February 3, 2015

RE: Southwest Light Rail Transit Project, Hennepin County, Minnesota; consultation on project effects related to the new Kenilworth Lagoon crossing, SHPO #2009-0080

Kenilworth Lagoon/Channel Crossing Options *Engineering Plans*

Kenilworth Lagoon/Channel Revised Bridge Design Concepts

## **Kenilworth Lagoon/Channel Revised Bridge Design Concepts**

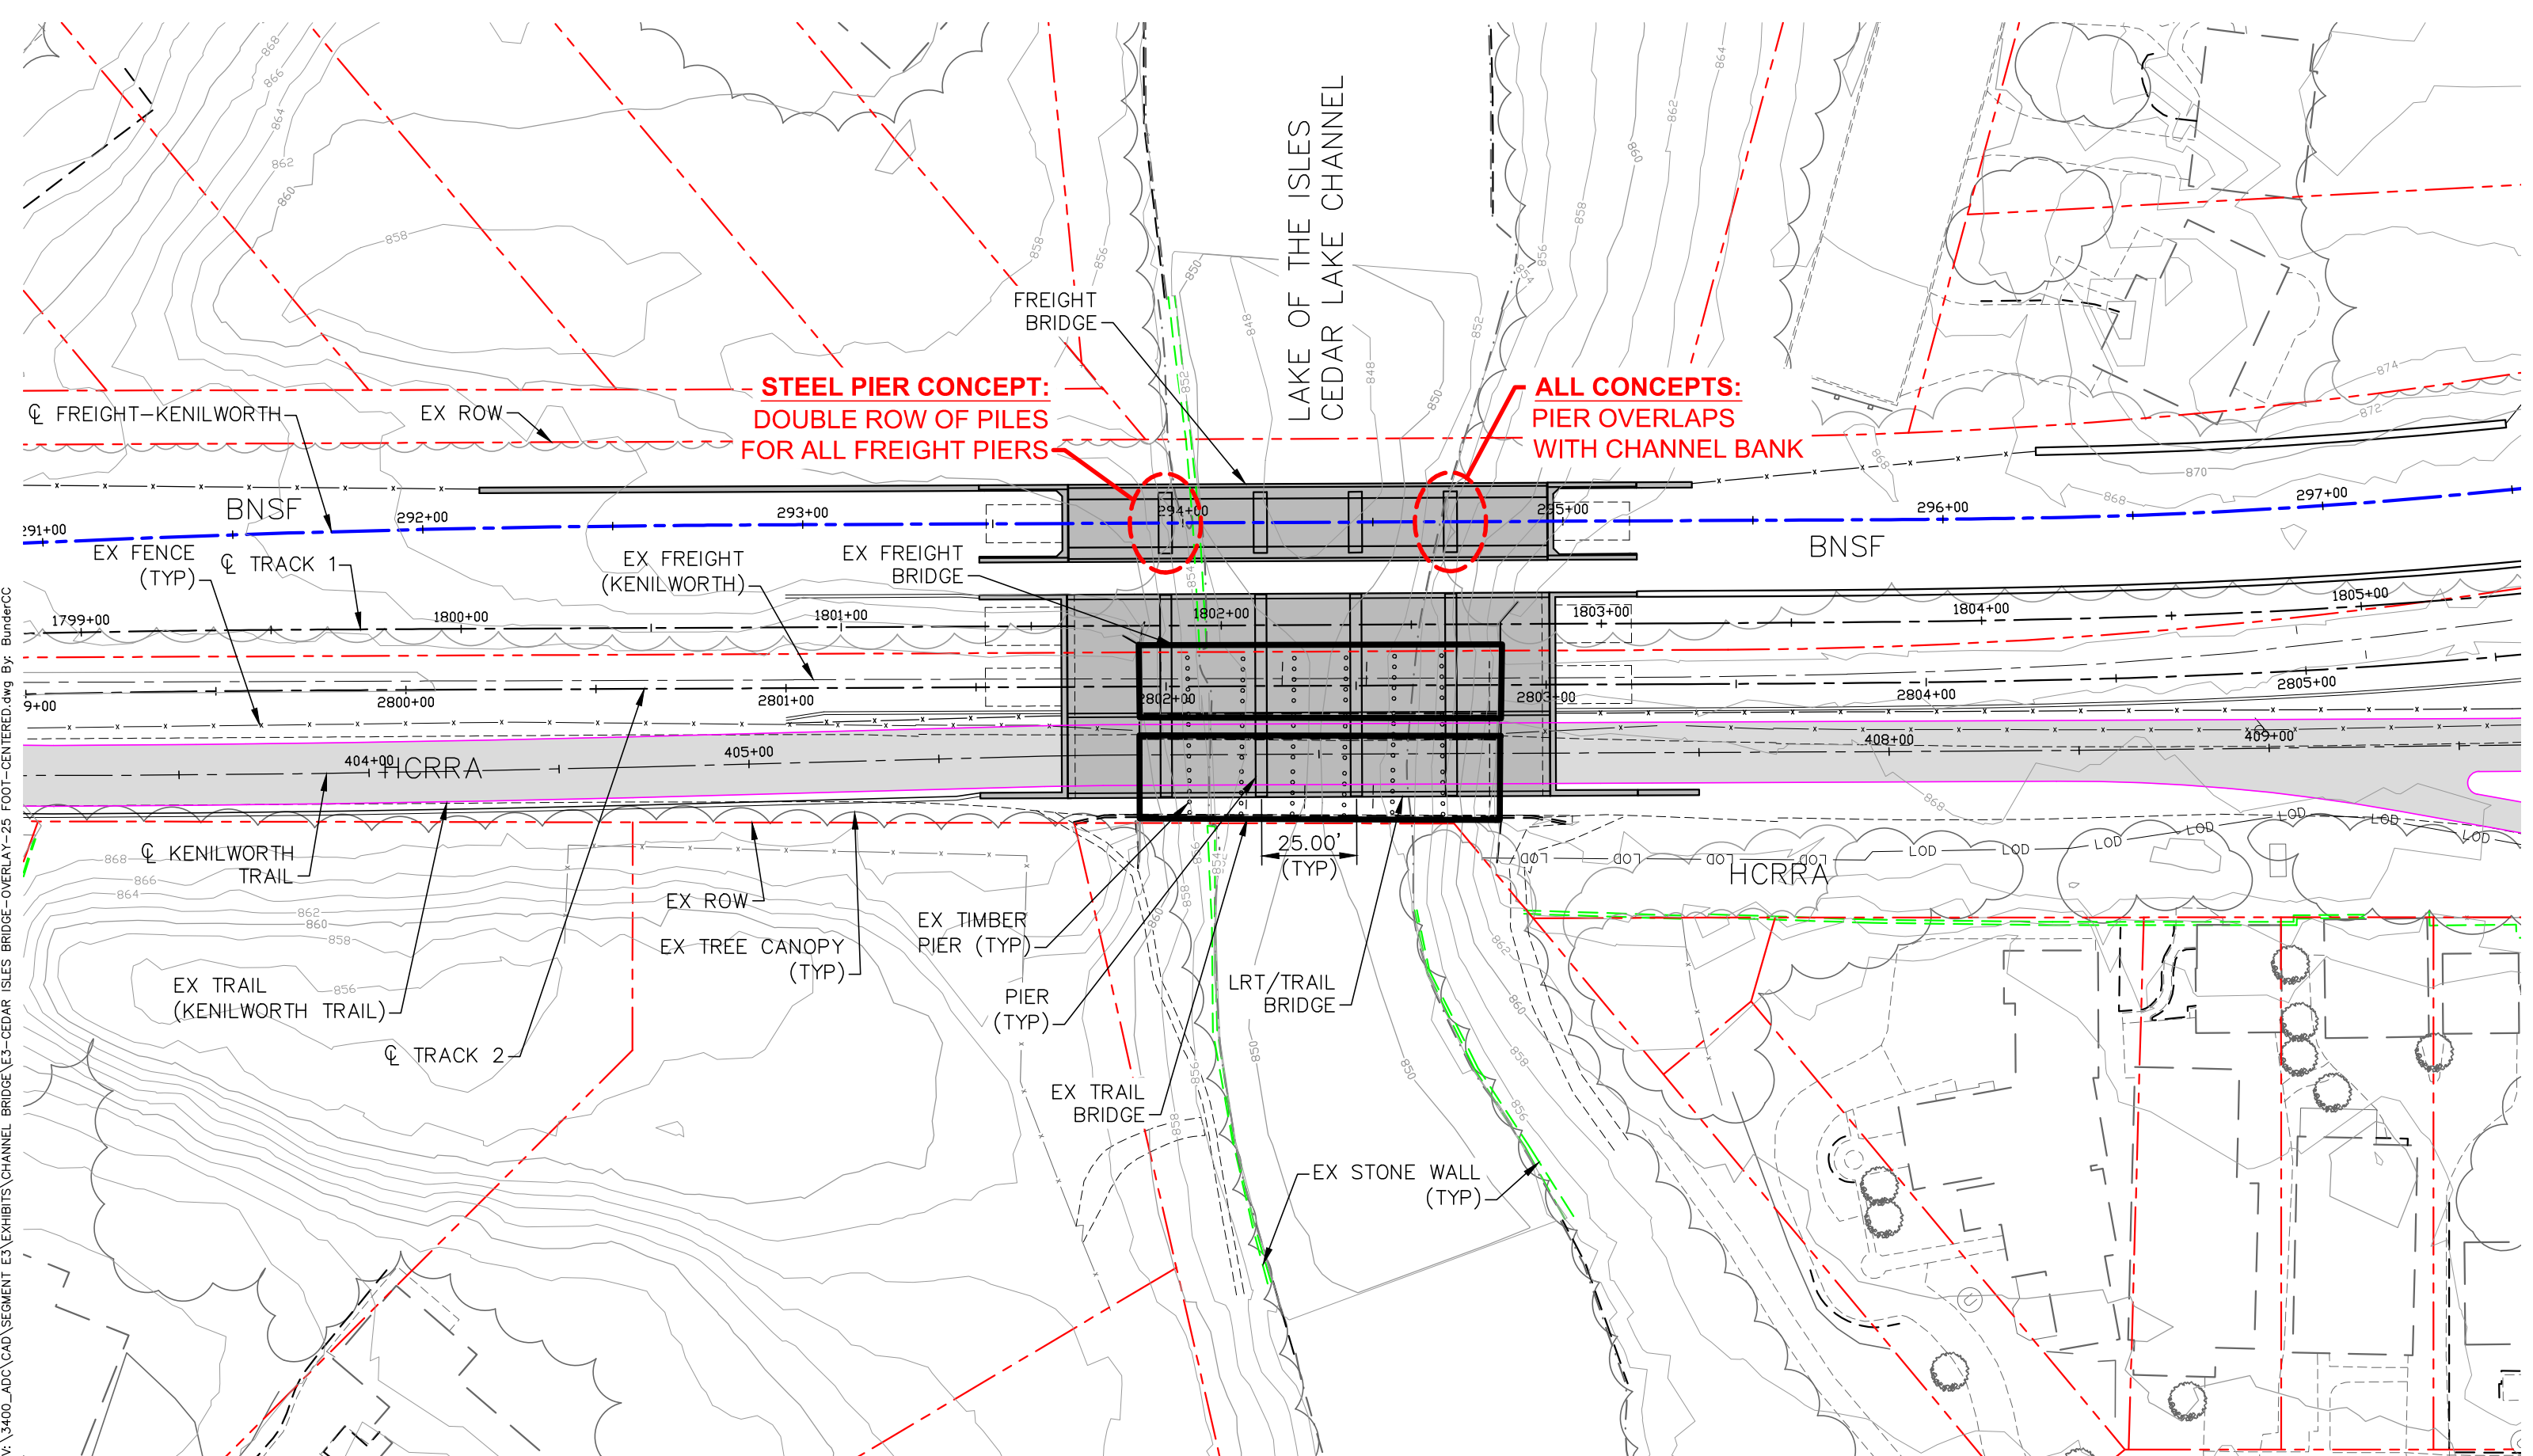
*Revised bridge design concepts based upon consulting party comments*
